PCN #: 2484

PCN Title: Qualification of Internal "Diodes Technology (Cheng Du) Company Limited" (CAT) as Additional Assembly & Test Site Using PdCu or Au Bond Wire, And Standardization of Assembly Bill of Materials At The Existing CAT Site for Select Discrete Products

**PRODUCT CHANGE NOTICE**

**PCN-2484 REV 1**

**TSOT23-6**

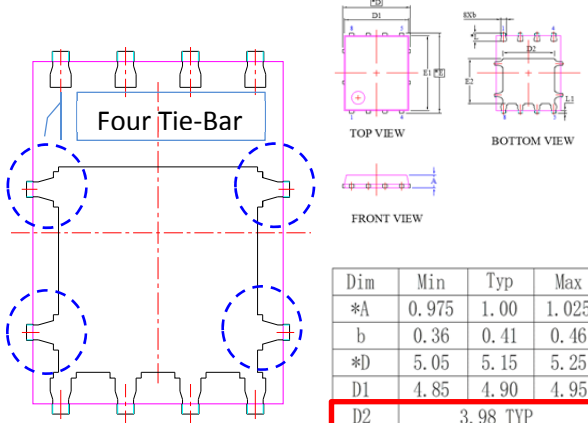
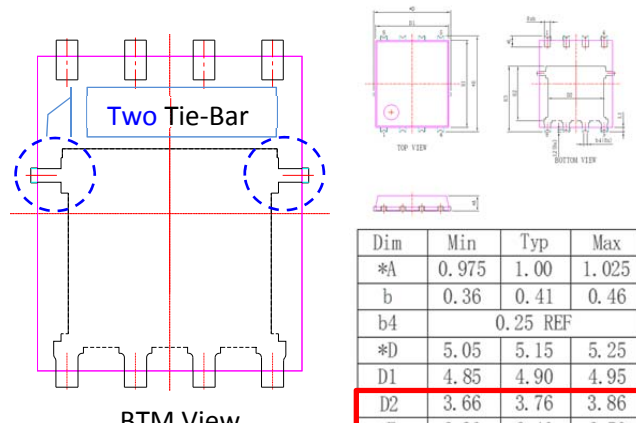
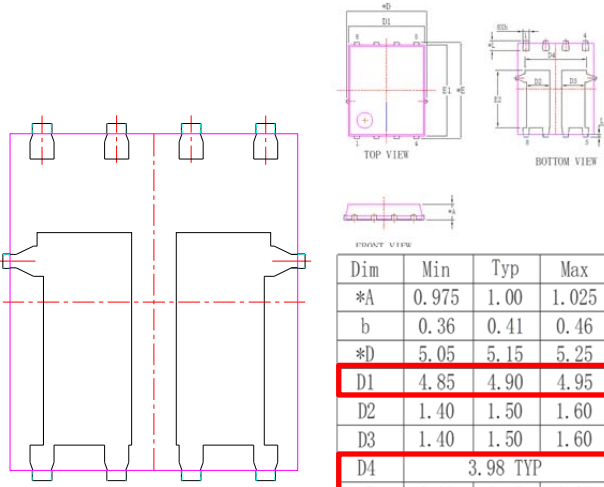
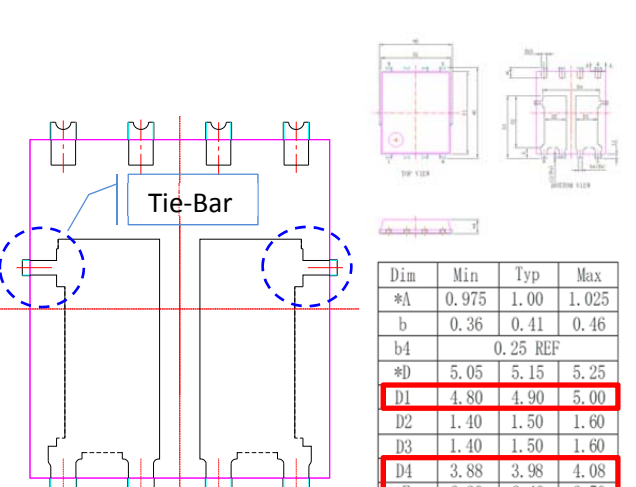
<b>SAT (Diodes Internal AT site Shanghai, China)</b>	<b>CAT (Diodes Internal AT Site Chengdu, China)</b> <i>Add bar "-" above Year D/C for CAT site</i>
Marking format example	Marking format example
